Manual Supplement

Manual Title: 1760 Users
Print Date: June 2006
Revision/Date: 2, 5/10

Supplement Issue: 1
Issue Date: 2/11
Page Count: 1

Change #1, 57261, 57516

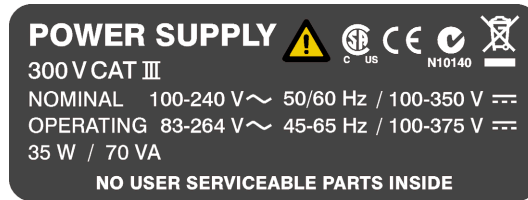
On page 1-7, replace the first Figure with the following:
